REGIONAL REVIEW FINDING

ARC REVIEW CODE: R1606271

Name of Proposal: Locust Grove-Clayco (DRI #2584)

DRI PLAN
LOCUST GROVE - CLAYCO
HENRY COUNTY, GA
APRIL 8, 2016

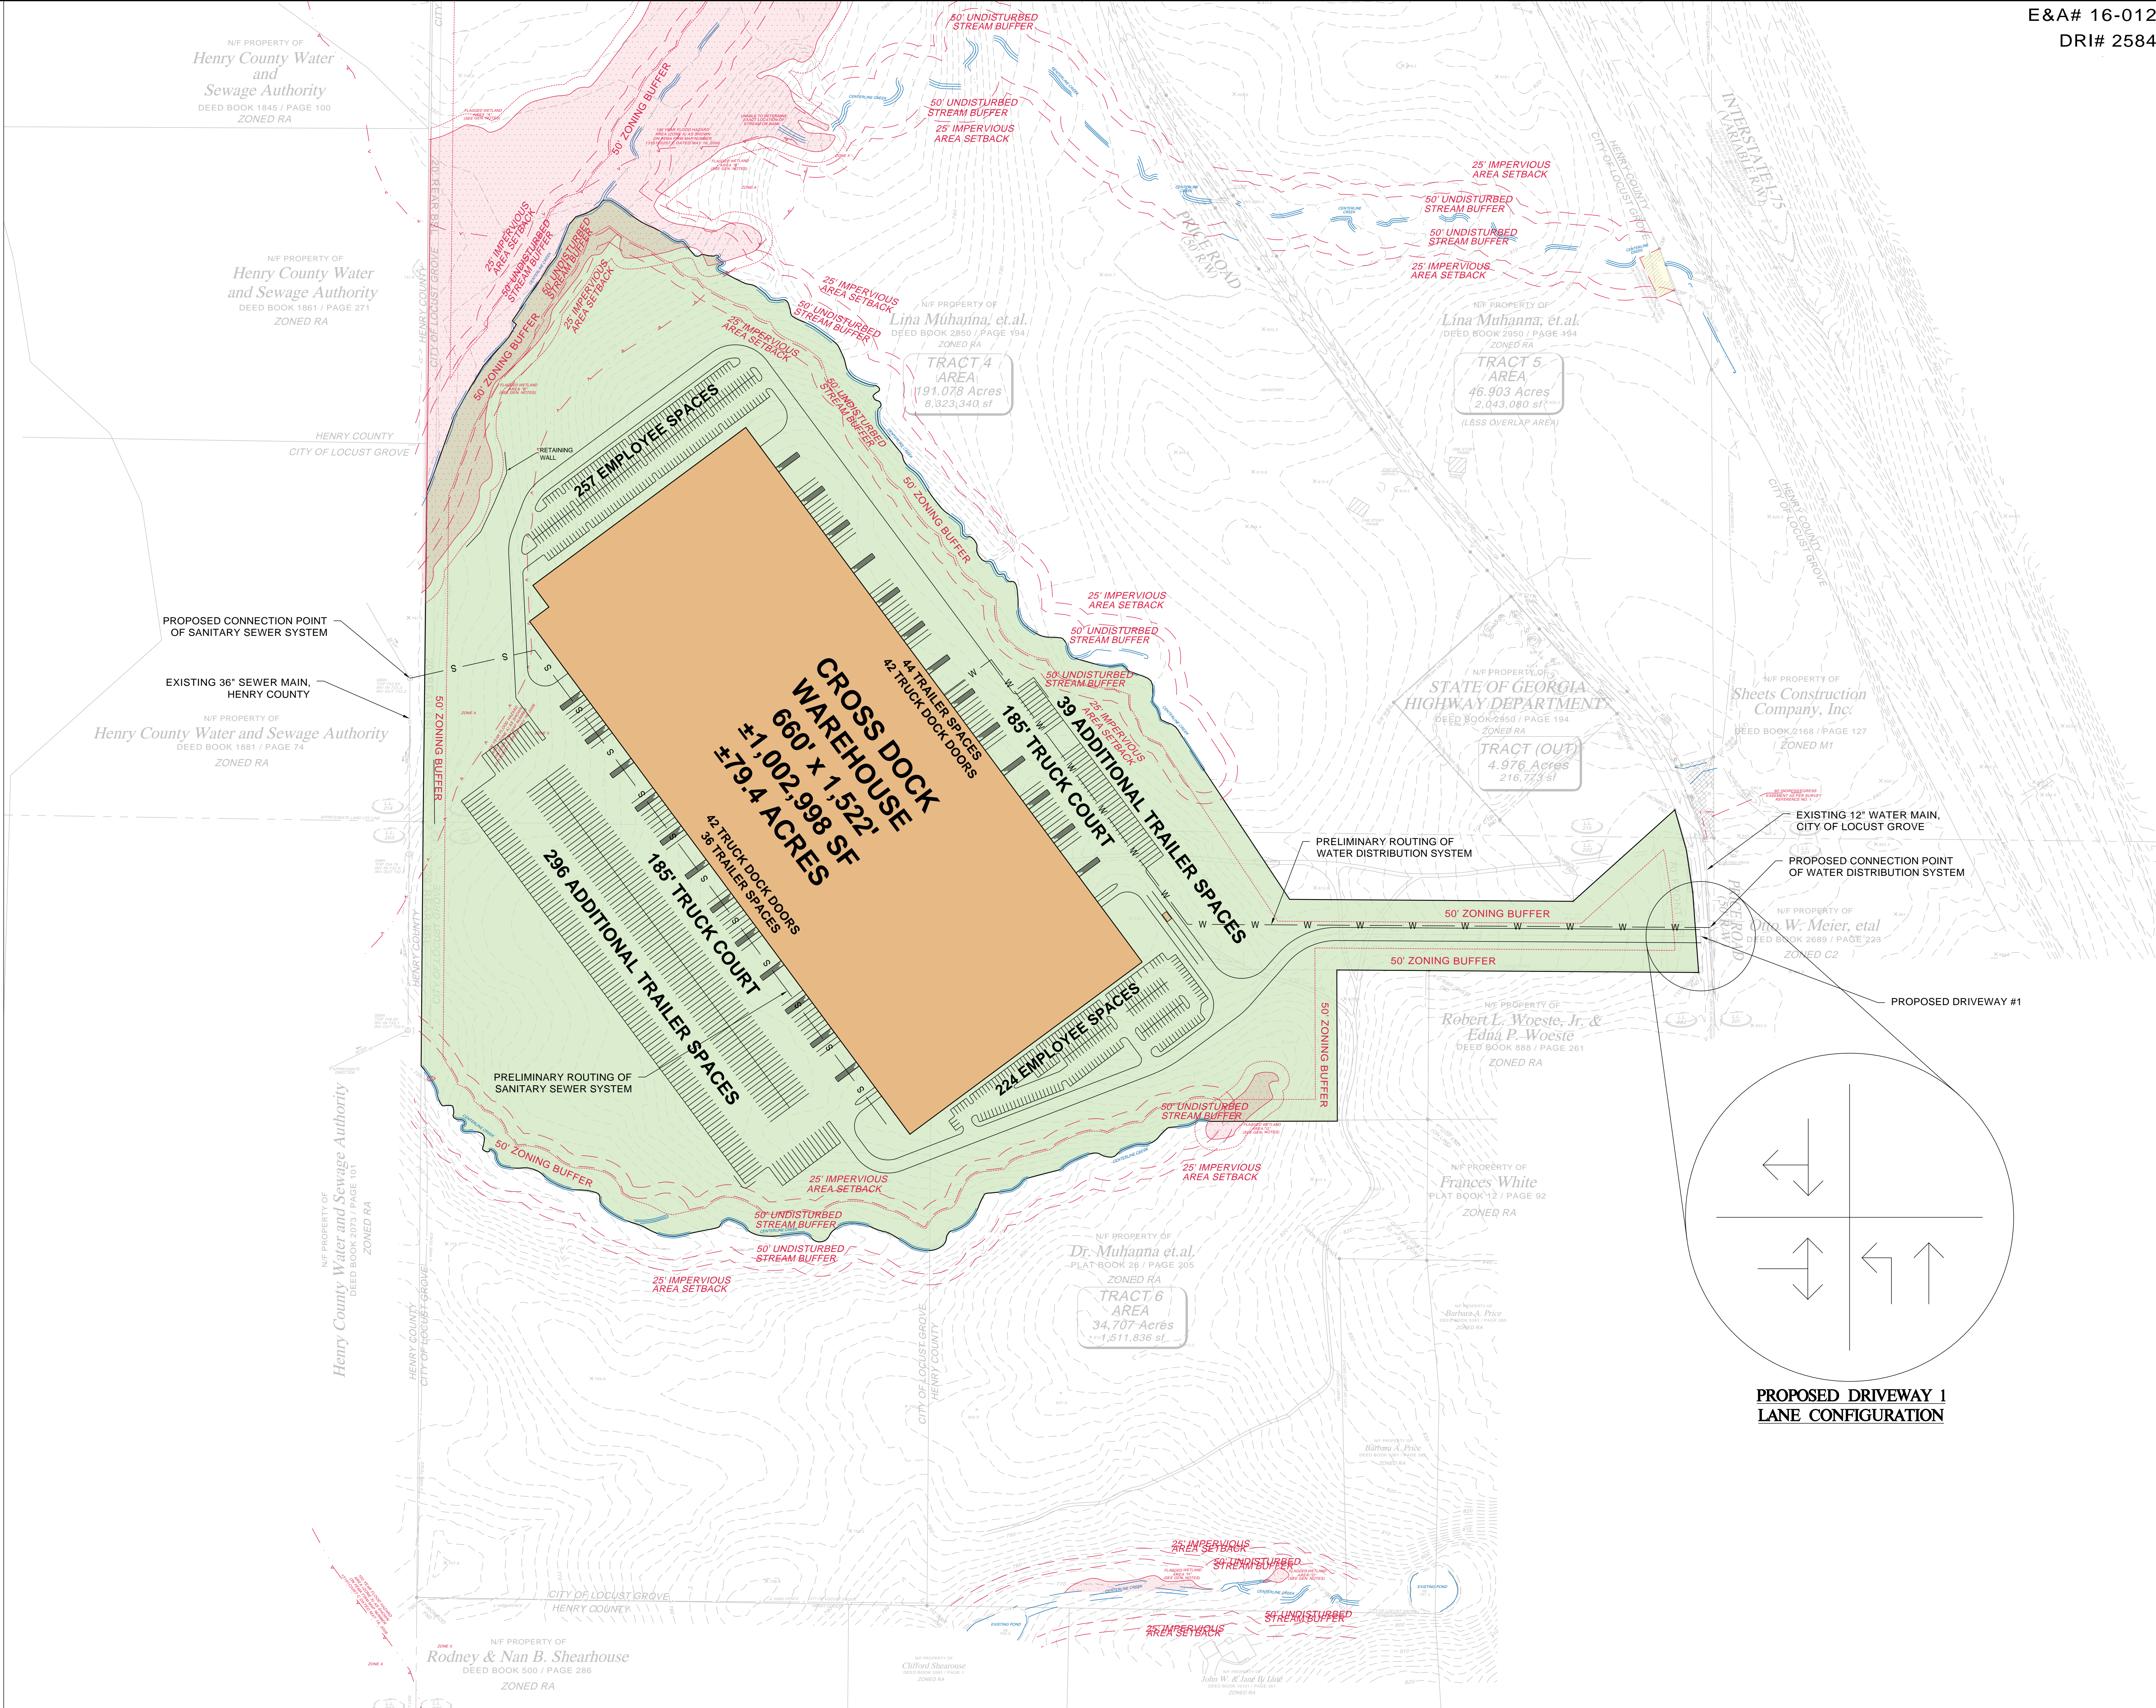
The submitted site plan shows streams along the northeast, northwest and southern boundaries of the project property, with 50-foot undisturbed buffers and additional 25-foot impervious surface setbacks (75-foot total) on all of them. No proposed development is shown within the buffers on the project plans. The USGS coverage for the project area also shows the streams as blue-lines and also shows them as tributaries of Indian Creek, which is west of the project property.

The project plans also show stream 100-year floodplain in the northern portion of the property, as well as wetland areas at the northern edge of the property. These areas will be subject to all applicable US Army COE requirements under Section 404 of the Clean Water Act as well as any City floodplain and wetland requirements. The wetland areas as well as all other waters of the state on the property, including the mapped streams, are also subject to the State Erosion and Sedimentation Act requirements, which include buffers.
